September 7, 2023
File No. 25222081.00

Subject: Materials Management Plan Addendum
Hartmeyer Property Development
2007 Roth Street, Madison, WI
BRRTS #s 03-13-000053 and 02-13-580328

SCS Engineers (SCS) is submitting this Materials Management Plan (MMP) Addendum in response to your email of July 28, 2023, with questions regarding the MMP that SCS submitted on behalf of Lincoln Avenue Capital on July 7, 2023. The questions posed in your email are reproduced below in italics with our responses shown below each question.

SHEET TITLE: **LANDSCAPE PLAN - OVERALL**

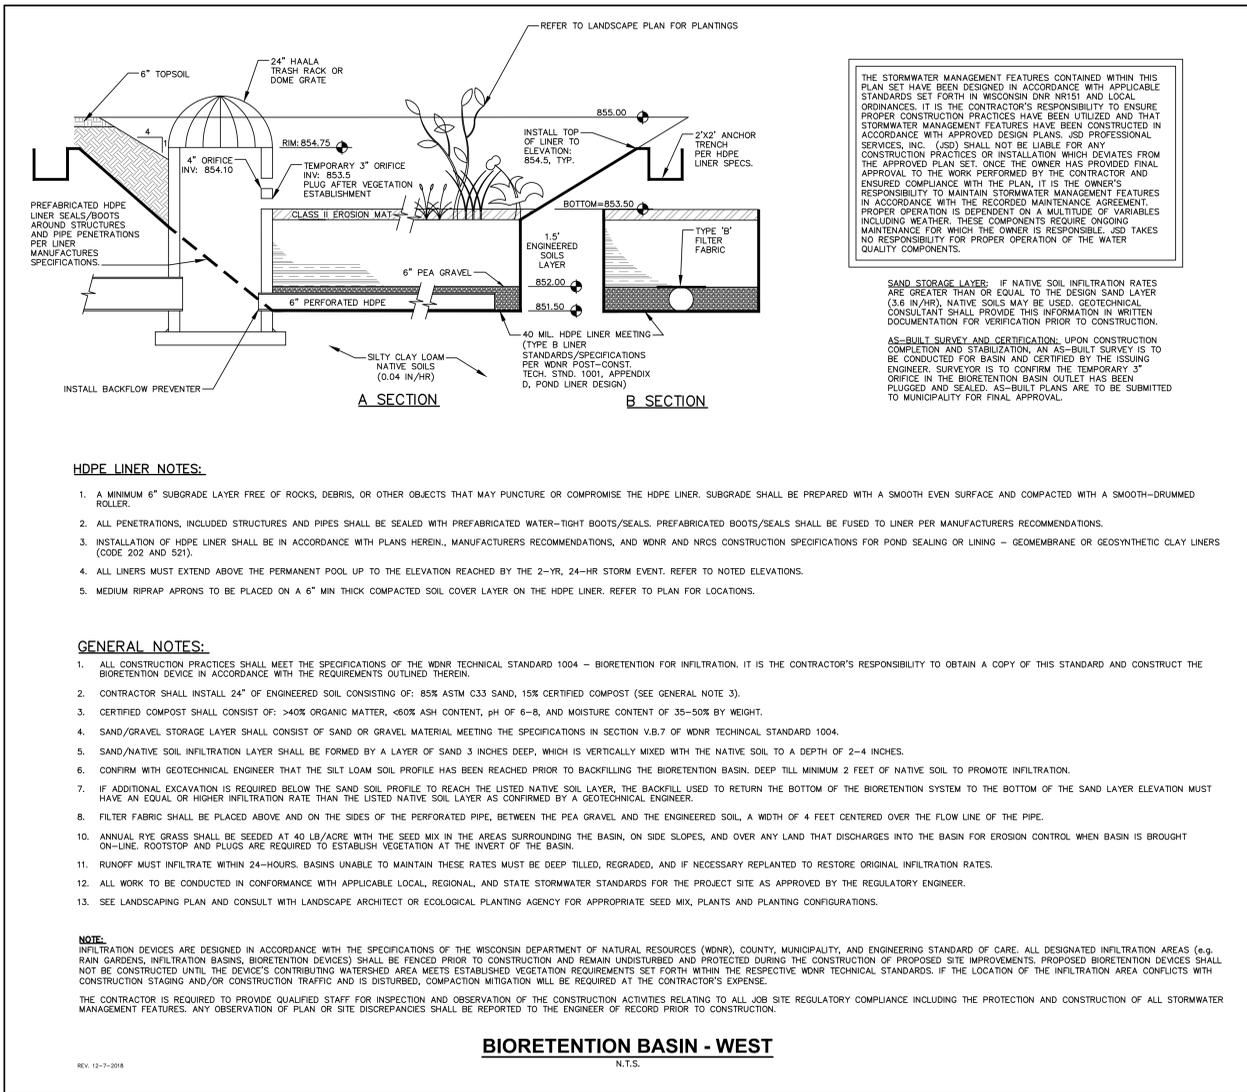
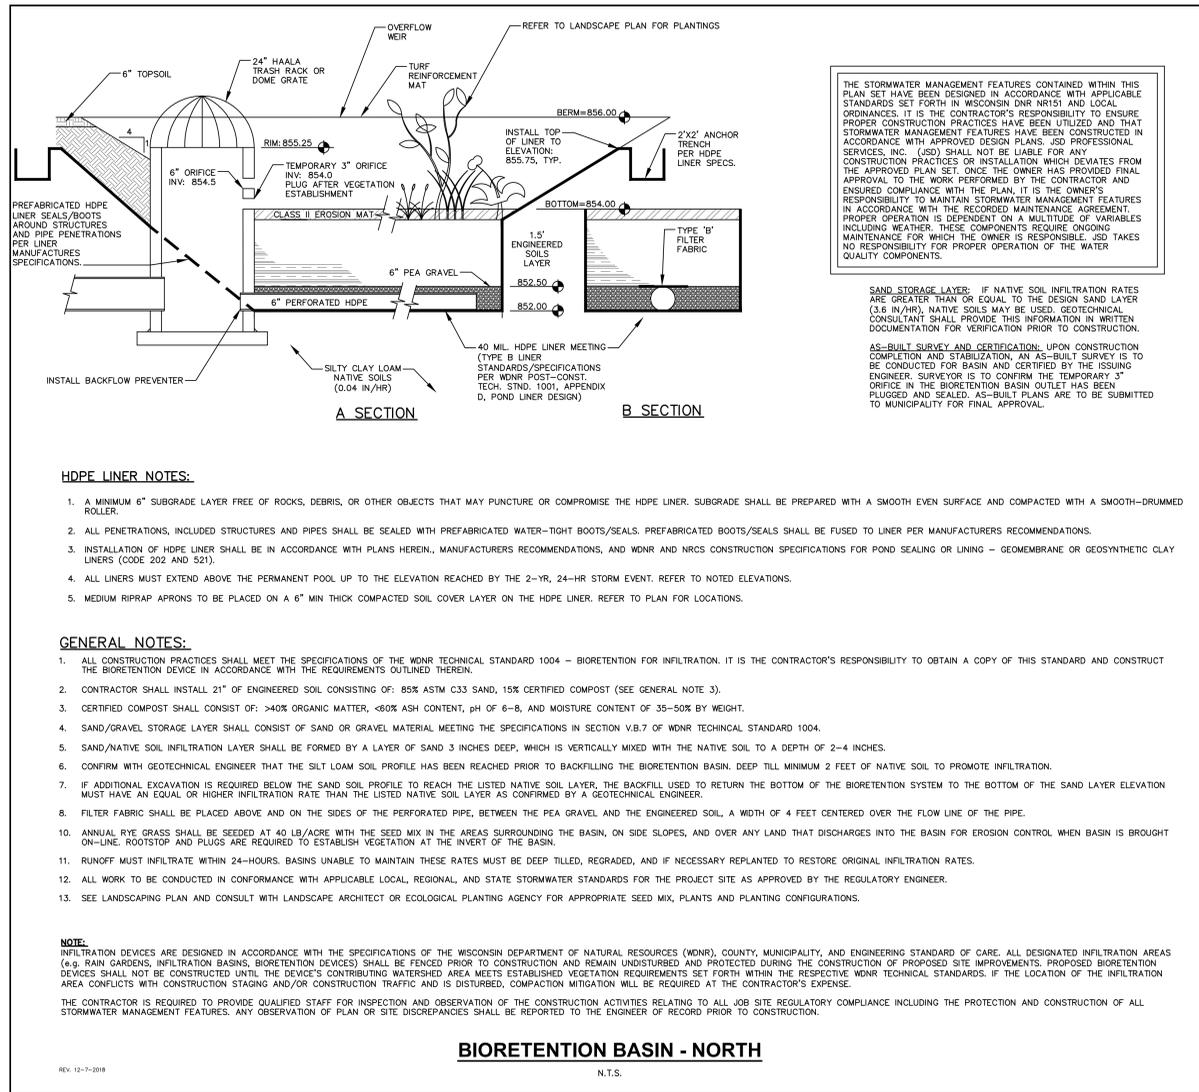
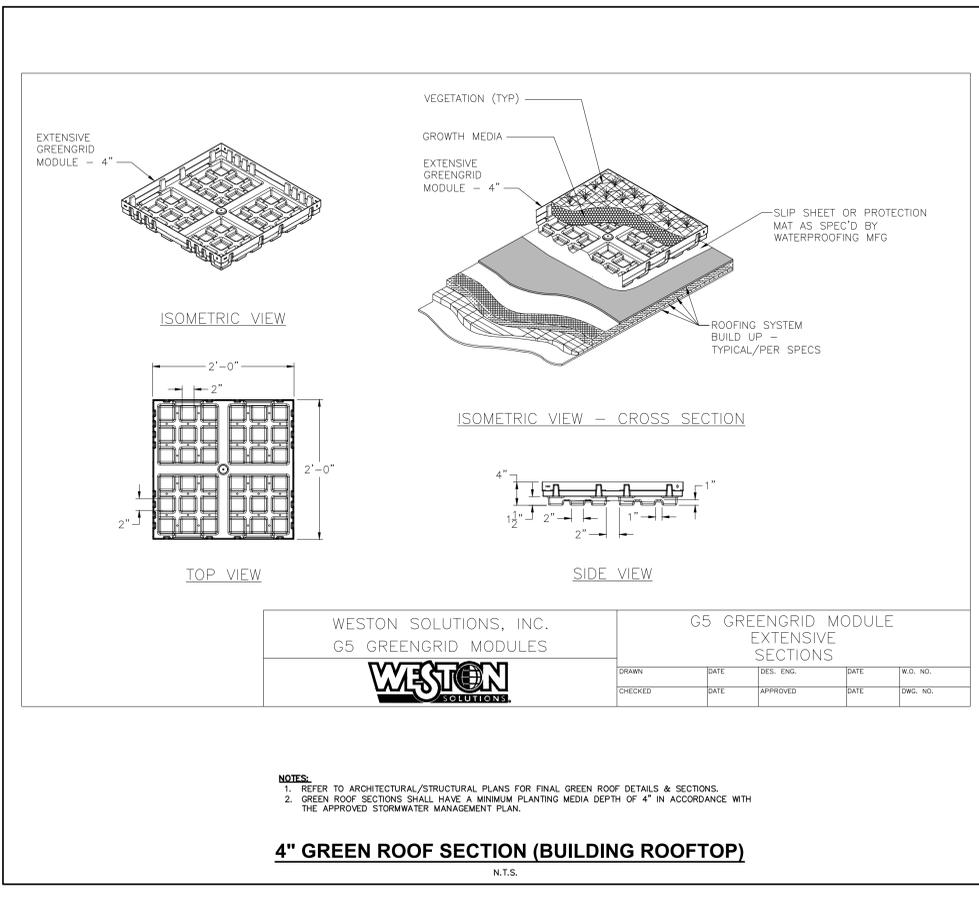
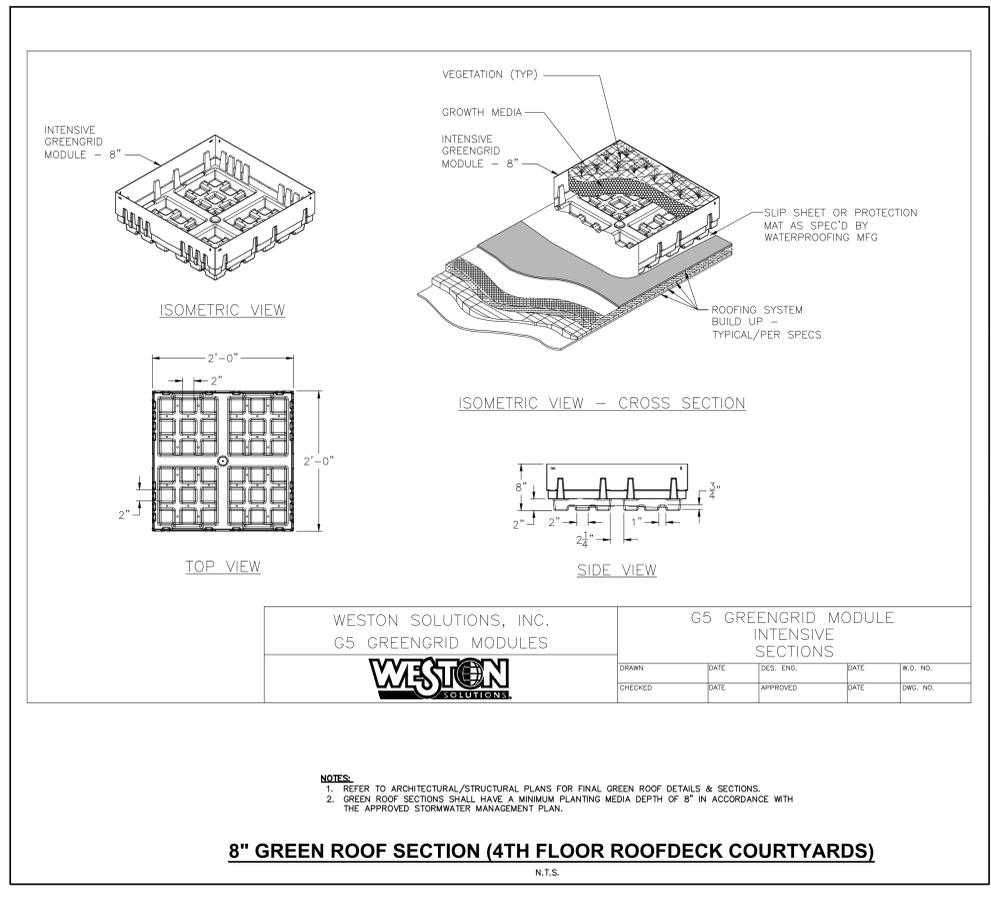
9. *Section 5.4, Protective Cap:*
 - a. *Provide a map indicating proposed capped areas (whether by soil, building, road, or other structure)*
 - b. *DNR's RR-709 guidance (attached, along with its companion document RR-528) recommends 2 feet of clean soil over contaminated soil, instead of the 1 foot proposed in your MMP; discuss whether this can be upgraded to a minimum of 2 feet and how it would be protective if only 1 foot.*
 - c. *Will any of the proposed dog runs or children's play areas, both of which could experience digging, be capped areas?*

The proposed cap is limited to the areas affected by the current redevelopment plans for the property. Because of the relatively widespread nature of urban fill soil and associated arsenic and PAH contamination, the entire developed portion of the property will effectively be capped by new buildings, lined pools or stormwater features, asphalt, concrete, or other paving materials, and/or at least 1 foot of clean soil in landscaped areas. The stormwater ponds will incorporate a 40-mil plastic

liner to prevent infiltration and contact with underlying soil. Bio-swales adjacent to the public streets will also be constructed with impermeable liners. The types of ground cover material are shown on the landscape plans provided in **Attachment B**.

The thickness of the clean soil cap in areas not covered by other materials will be a minimum of one foot. The minimum cap thickness in designated play/dog run areas will be 2 feet. The maximum soil cap thickness will vary depending on the amount of clean fill needed to achieve the desired grades. Because the landscaping will be maintained by a property manager rather than individual residents, the likelihood of unauthorized cap disturbance and exposure of residents and the general public to remaining contaminants in the underlying soil will be minimal. To the extent possible, the full thickness of contaminated materials or 4 feet of contaminated materials (whichever is less) will be removed in areas such as child play areas or dog runs where incidental digging in the soil cap may occur. If the contaminated material remains within 4 feet of the ground surface in capped areas where incidental digging may occur, the clean soil will be underlain by permeable geotextile or similar material to demarcate the bottom of the cap.
